SERVICE BULLETIN

Subject: Transmittal of Revision 1 to Service Bulletin Number V2500-NAC-78-0138

**NACELLE - EXHAUST - LOWER THRUST REVERSER, CORE DRAIN MAST
MODIFICATION OF**

V2500-NAC-78-0138

Lower Thrust Reverser Core Drain Mast Tube Assembly Modification
Figure 1 (Sheet 2)

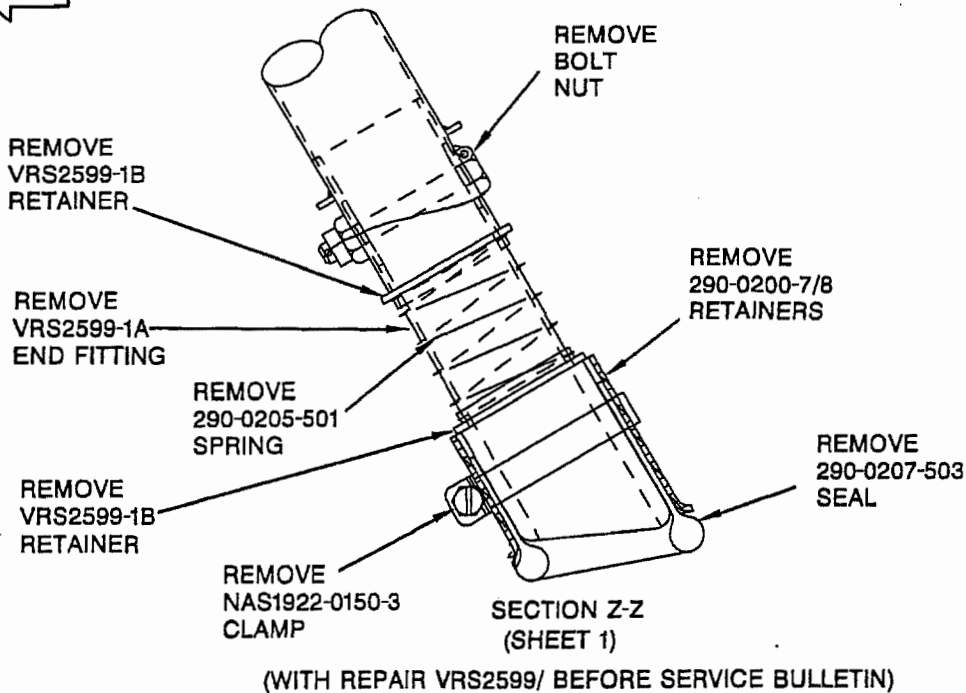
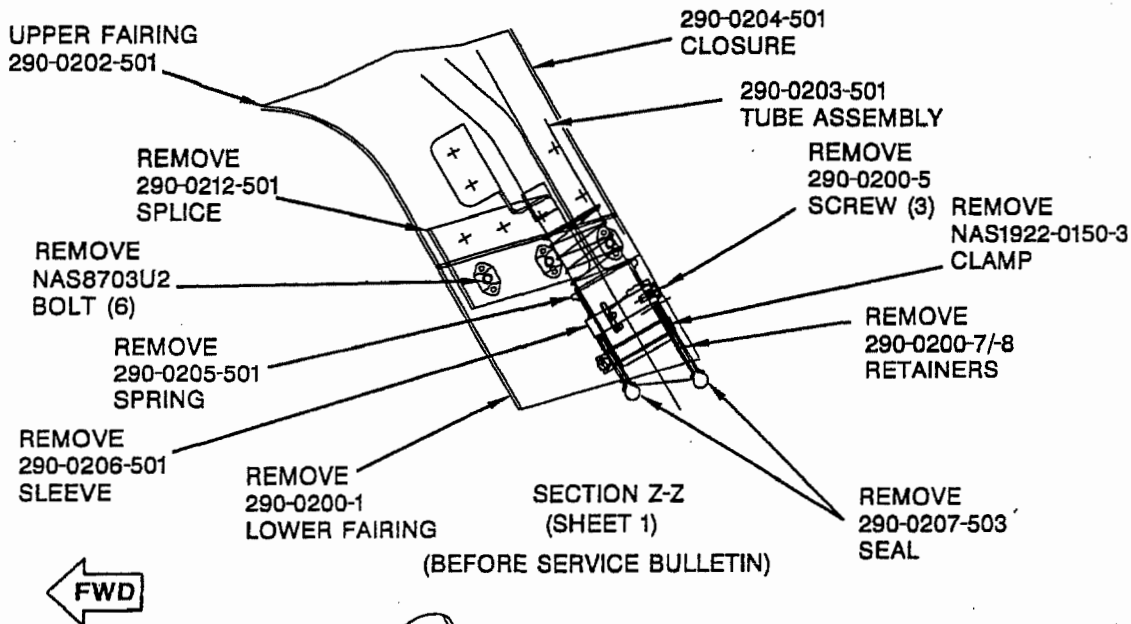
- (1) Remove the six NAS8703U2 bolts and the 290-0200-1 lower fairing from the 290-0212-501 splice and 290-0204-501 closure. Discard the bolts and the lower fairing. Refer to Figure 1, sheet 2.
- (2) For thrust reversers with repair VRS2599:
 - (a) Remove the NAS1922-150-3 clamp, the 290-0200-7 and 290-0200-8 retainers, the 290-0207-501 seal, the VRS2599-B retainers, and the 290-0205-501 spring from the VRS2599-A end fitting. Discard the VRS2599-B retainers and the spring. Refer to Figure 1, sheet 2.
 - (b) Remove the nut, bolt, and end fitting VRS2599-A from the tube assembly. Discard the nut, the bolt and the end fitting. Refer to Figure 1, sheet 2.
- (3) For thrust reversers without repair VRS2599:
 - (a) Remove the NAS1922-150-3 clamp, the 290-0200-7 and 290-0200-8 retainers, and the 290-0207-503 seal from the 290-0203-501 tube assembly. Refer to Figure 1, sheet 2.

- R (b) Remove the three 290-0200-5 screws, the 290-0206-501
R sleeve, and the 290-0205-501 spring from the 290-
0203-501 tube assembly. Discard the screws, the
sleeve, and the spring. Refer to Figure 1, sheet 2.

Lower Thrust Reverser Core Drain Mast Tube Assembly Modification
Figure 1 (Sheet 4)

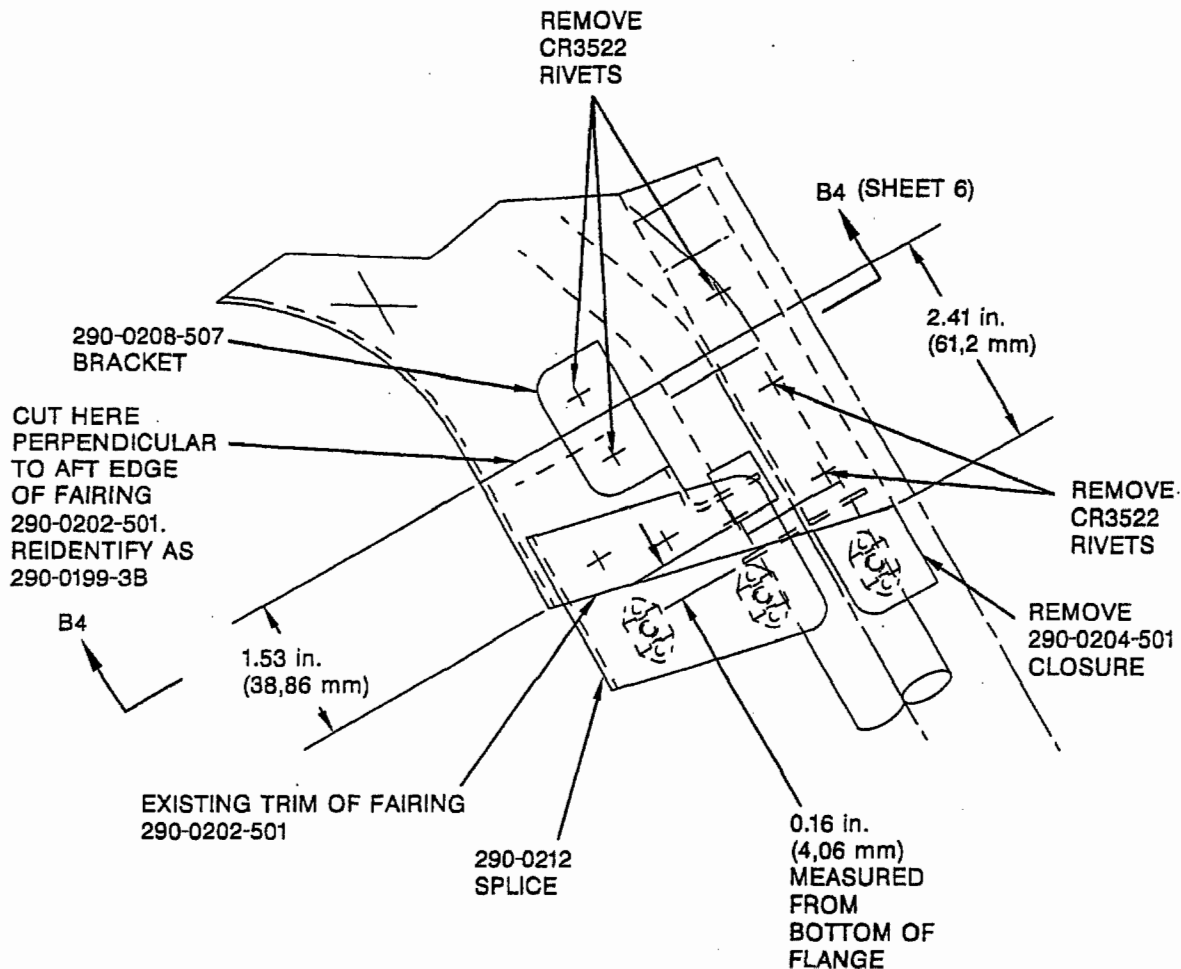
- R (5) Remove the rivets and the 290-0204-501 closure as shown in
R Figure 1, sheet 4.
- R (6) Remove 2.41 inches (61.2 mm) from the bottom aft edge of
R the 290-0202-501 fairing. Make sure the cut is perpendicu-
R lar to the aft surface and does not affect the 290-0203-501
tube assembly. Remove all burrs and sharp corners. Refer to
Figure 1, sheet 4.

Lower Thrust Reverser Core Drain Mast Tube Assembly Modification
Figure 1 (Sheet 5)

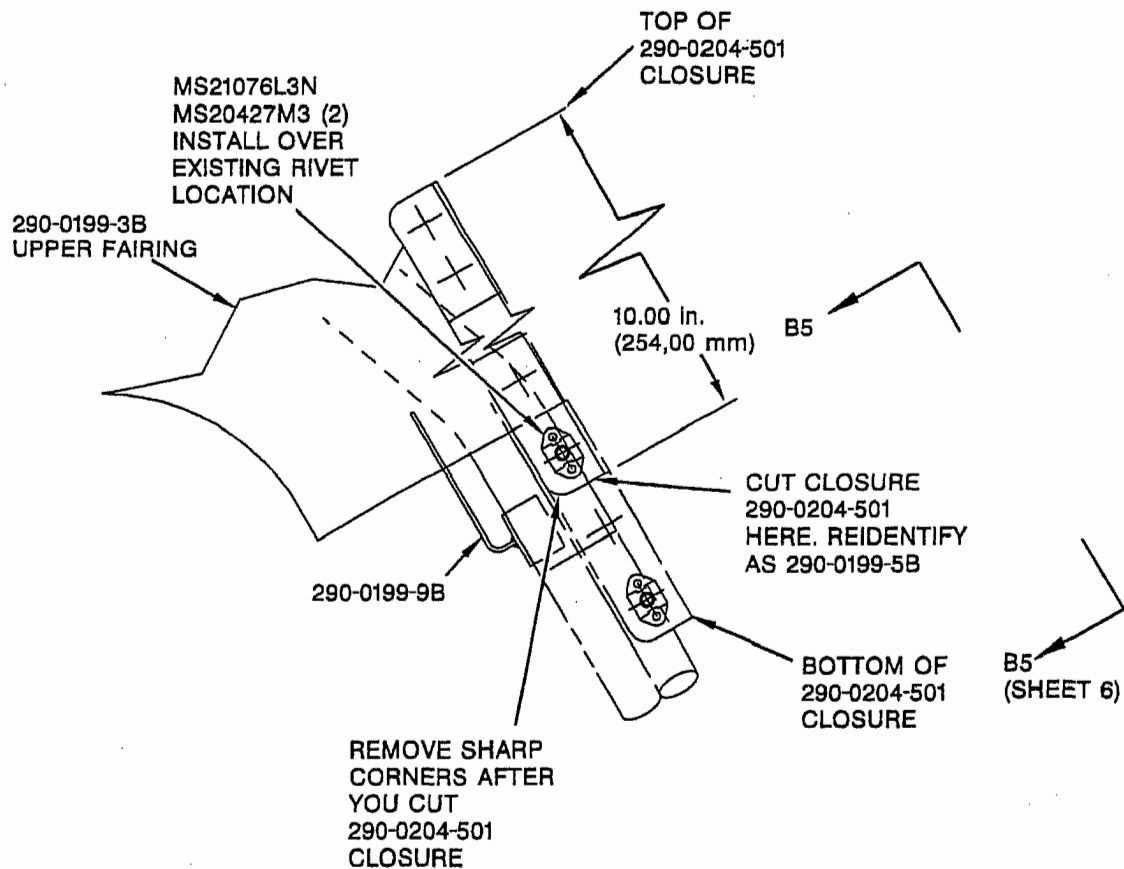
00.
- R (8) Remove material from the 290-0204-501 closure as shown in
R Figure 1, sheets 5 and 6. Remove all burrs and sharp cor-
R ners.
- R (9) Reidentify the closure from 290-0204-501 to
290-0199-5B. Use ink (CoMat 06-073) and a rubber stamp.
Refer to the IAE V2500 Standard Practices/Processes
Manual, Chapter 70-09-00.

- (17) Install two MS21076L3N nut plates on the 290-0199-5B closure assembly with the MS20427M3 rivets. Use existing fastener locations to locate nutplates. Wet install the rivets with the primer mix. Refer to Figure 1, sheet 5.
- (18) Put the 290-0199-1B flange into the 290-0199-9B tube assembly. Make sure the fastener holes which are 1.09 inches (27.69 mm) apart are pointed aft. Drill holes for and install three CR3523-5-2 rivets. Wet install the rivets with primer mix. Refer to Figure 1, sheets 7, 8, 9, and 16.

Lower Thrust Reverser Core Drain Mast Tube Assembly Modification
Figure 1 (Sheet 6)

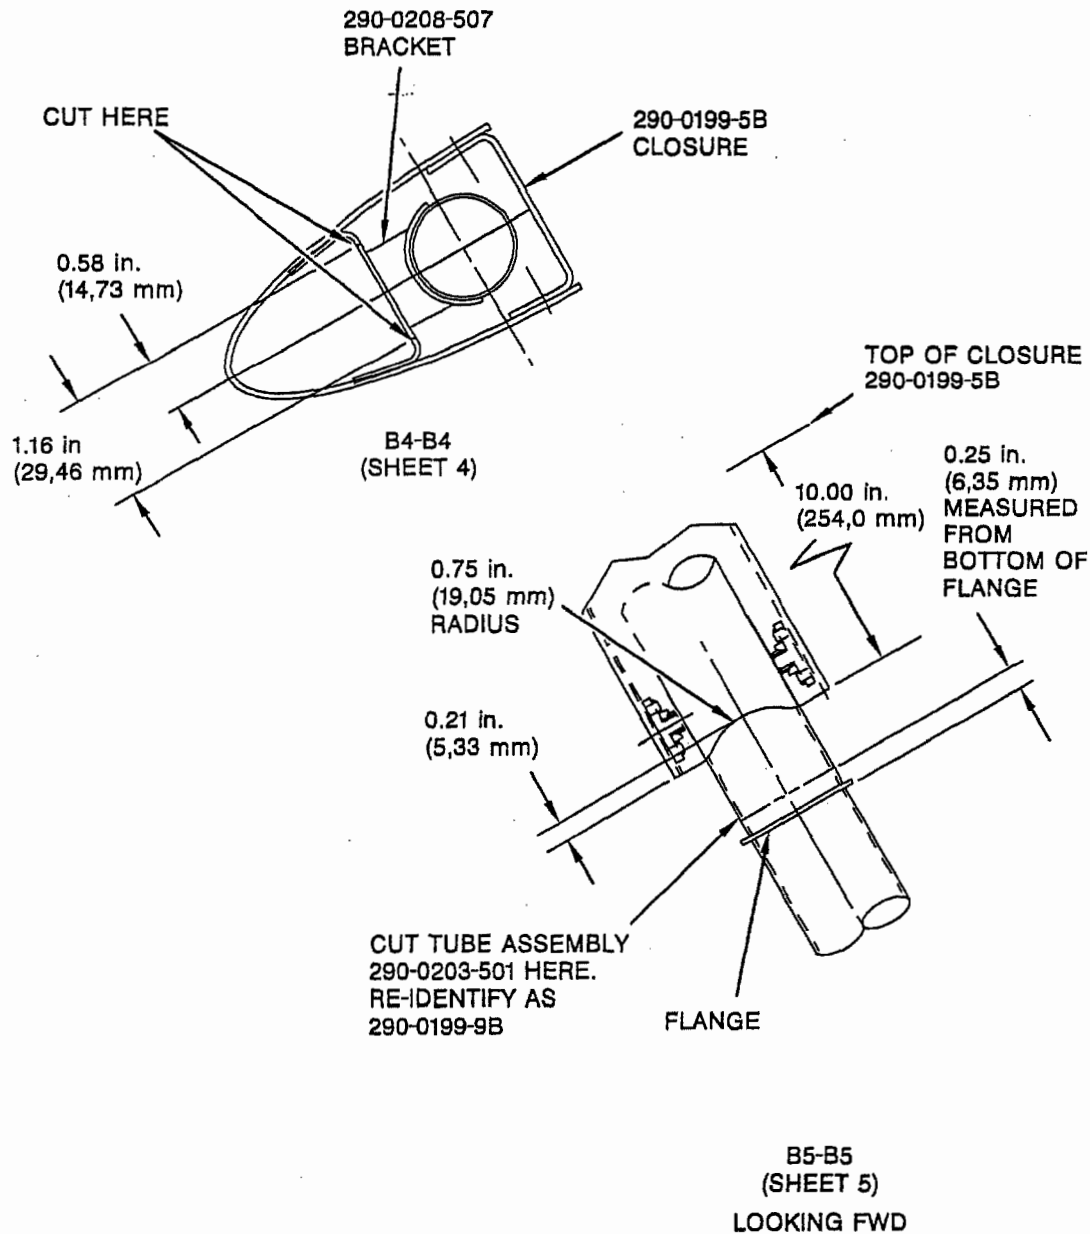
- R (10) Measure 0.25 inch (6.35 mm) up from the bottom of the
flange and make a cut through the 290-0203-501 tube
assembly. Make sure the cut is perpendicular to the tube
centerline. Remove all burrs. Refer to Figure 1, sheet 6.

- R (12) Remove material from the 290-0208-507 bracket on the tube
assembly. Remove all burrs and sharp corners. Refer to
Figure 1, sheet 6.

Lower Thrust Reverser Core Drain Mast Tube Assembly Modification
Figure 1 (Sheet 10)

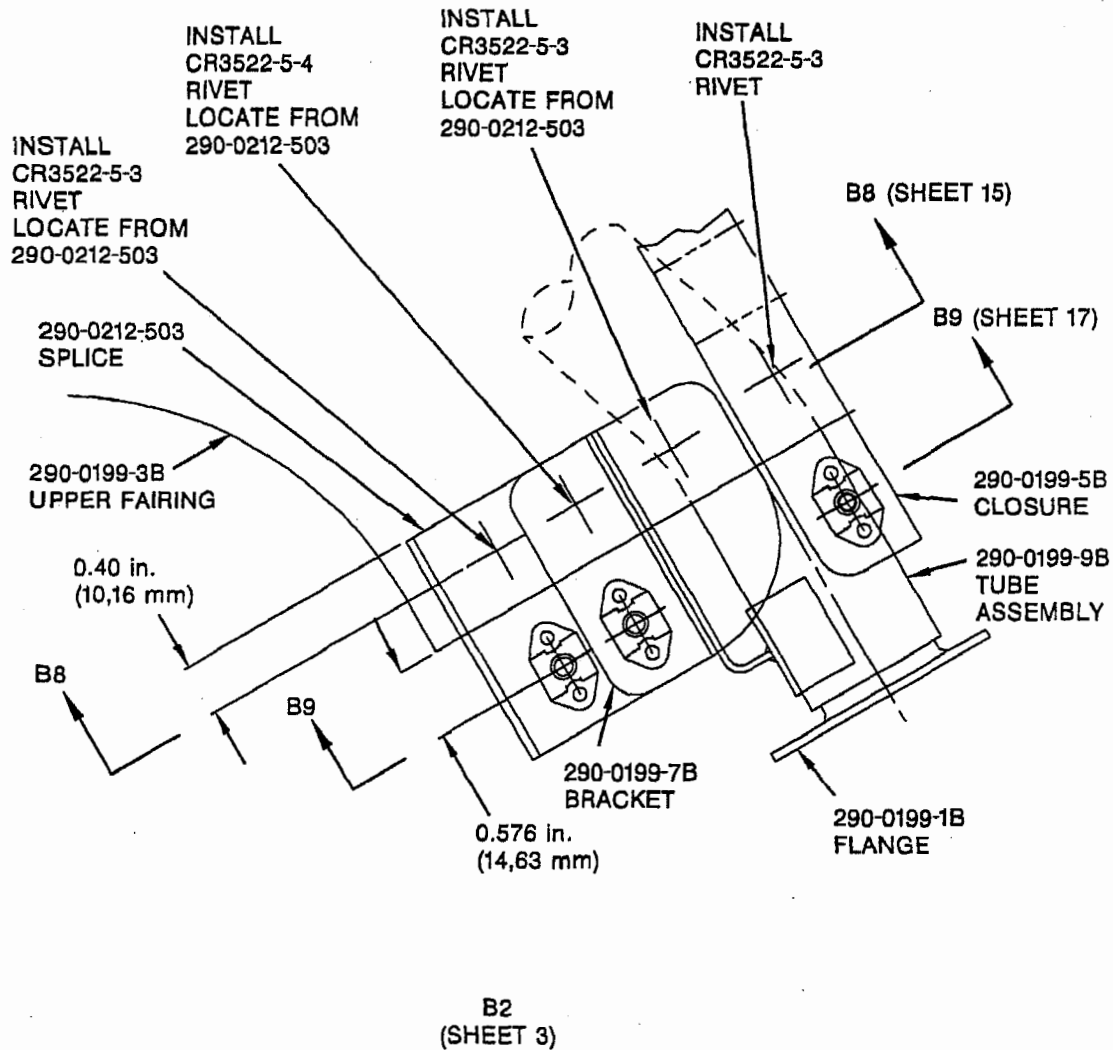
- (20) Install the 290-0199-5B closure with the MS3522-5-3 rivets. Wet install the rivets with primer mix. Refer to Figure 1, sheet 10.

- (22) Put the 290-0212-503 splice into position. Drill holes for and install the six CR3522-5-3 and two CR3522-5-4 rivets. Wet install the rivets with primer mix. Refer to Figure 1, sheet 10. Fill spaces up to 0.030 inch (0.762 mm) between the 290-0212-503 splice and the 290-0199-7B bracket with

liquid shim (CoMat 08-104). Fill spaces from 0.030 to 0.060 inch (0.762 to 1.52 mm) with liquid shim (CoMat 08-104) and S700S0497-83 (MIL-S-22499) laminated shim. Taper the laminated shim as required. Use liquid shim up to 0.030 inch (0.762 mm) maximum thickness. Fill spaces between the 290-0212-503 splice and the 290-0199-3B fairing and the 290-0199-5B closure with liquid shim (CoMat 08-104) only.

Lower Thrust Reverser Core Drain Mast Tube Assembly Modification
Figure 1 (Sheet 11)

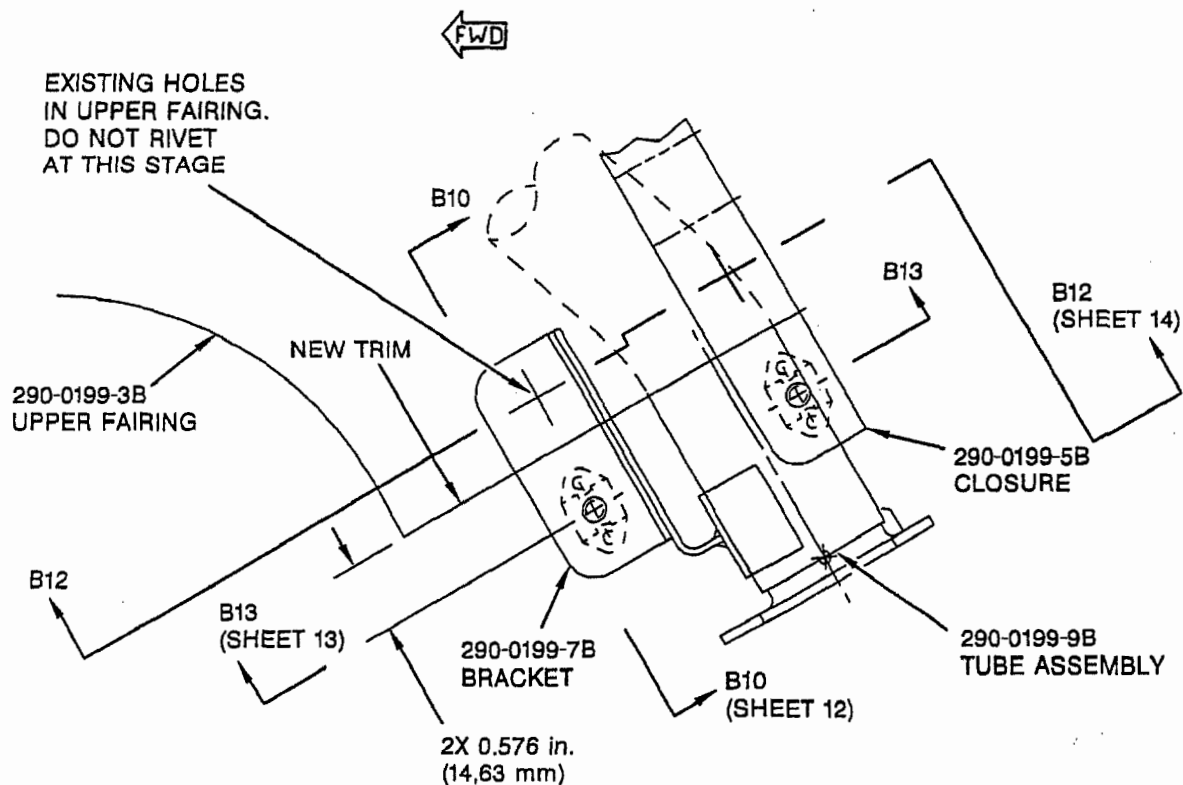
- (19) Put the 290-0199-7B bracket into position on the 290-0199-9B tube assembly bracket. Make sure equal space exists between the 290-0199-3B fairing and the 290-0199-7B bracket on both sides of the bracket. Drill holes for and install four CR3523-5-2 rivets through the 290-0199-7B bracket and the bracket on the tube assembly. Wet install the rivets. Refer to Figure 1, sheets 11, 12, and 13.

Lower Thrust Reverser Core Drain Mast Tube Assembly Modification
Figure 1 (Sheet 12)

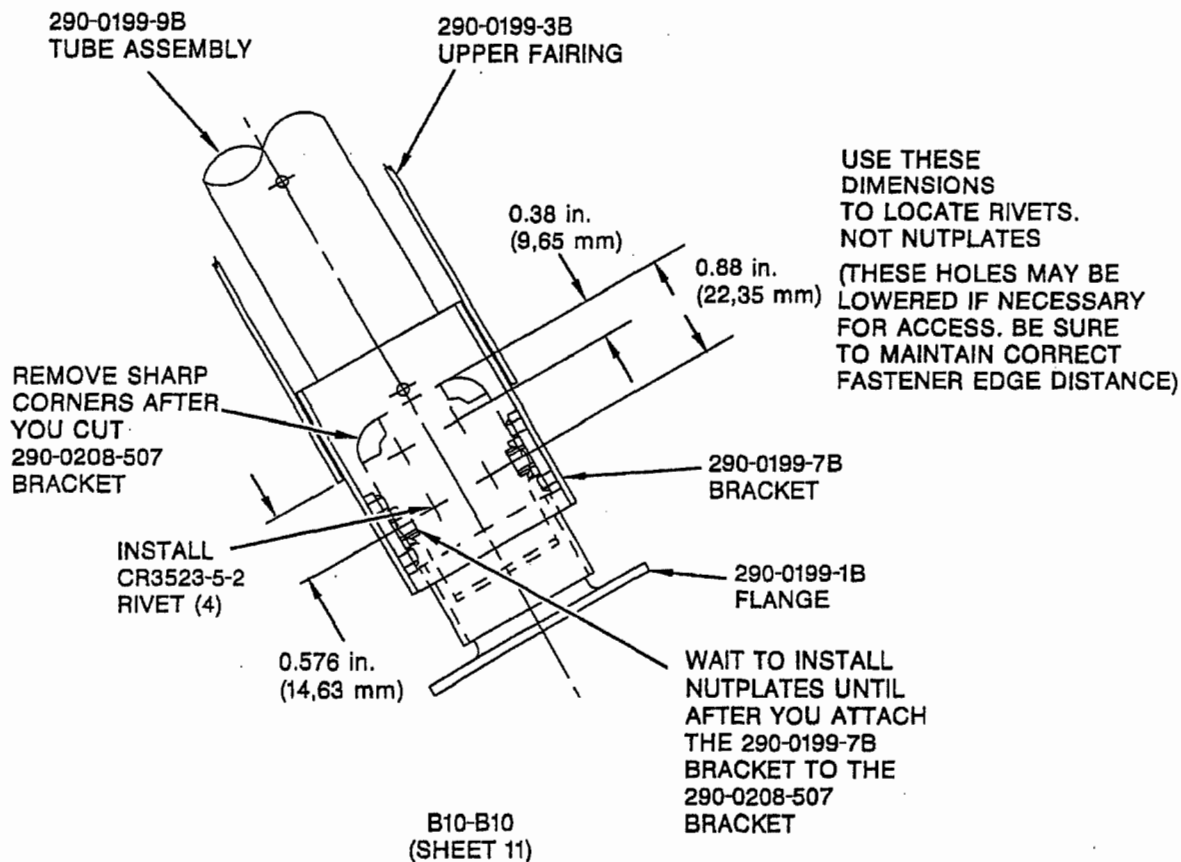
- (21) Put two MS21076L3N nutplates on the 290-0199-7B bracket over the existing holes. Drill holes for and install four MS20427M3-3 nutplate attach rivets. Wet install the rivets with primer mix. Refer to Figure 1, sheet 12.

Lower Thrust Reverser Core Drain Mast Tube Assembly Modification
Figure 1 (Sheet 16)

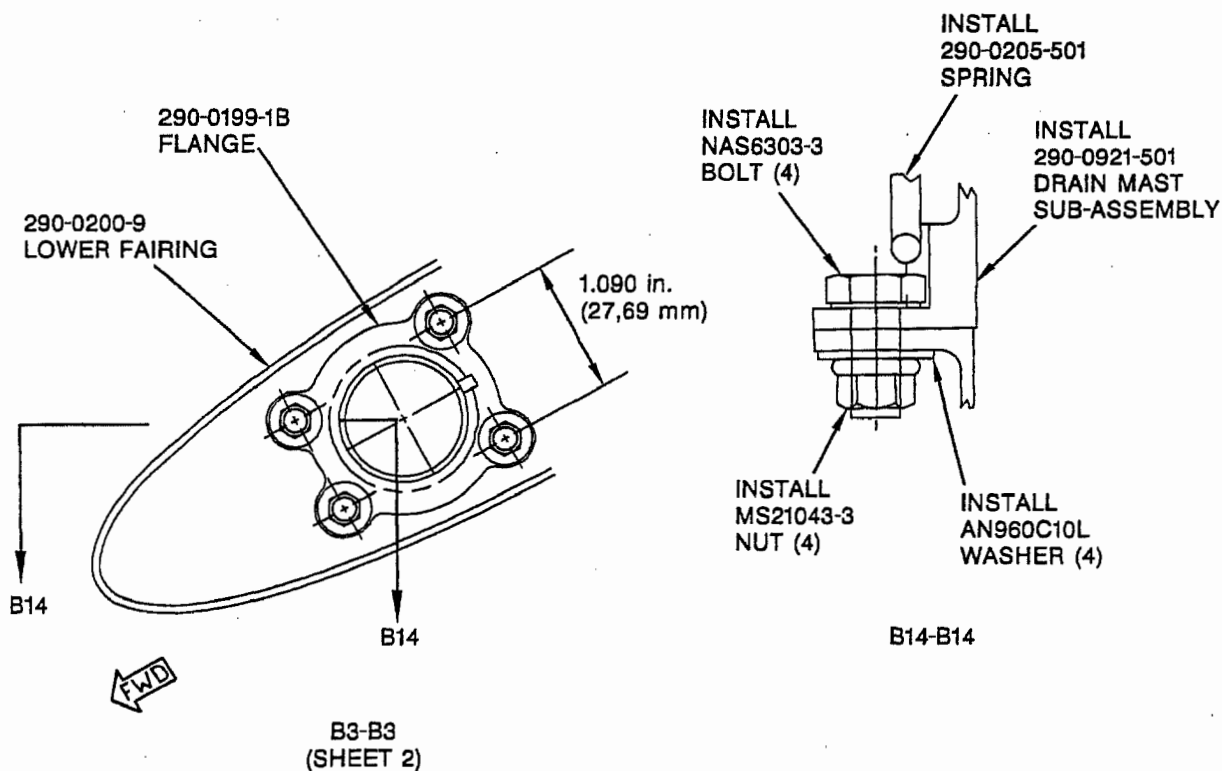
- (23) Attach the 290-0921-501 drain mast subassembly to the 290-0199-1B flange with four NAS6303-3 bolts, AN960C10L washers, and MS21043-3 nuts. Refer to Figure 1, sheet 16.
- (24) Install the 290-0207-503 seal, 290-0200-7 and 290-0200-8 seal retainers, and NAS1922-150-3 clamp on the drain mast subassembly. Refer to Figure 1, sheet 3.
- (25) Install the 290-0200-9 lower fairing with four NAS8703-2 bolts and two NAS8703-3 bolts. Refer to Figure 1, sheet 17.
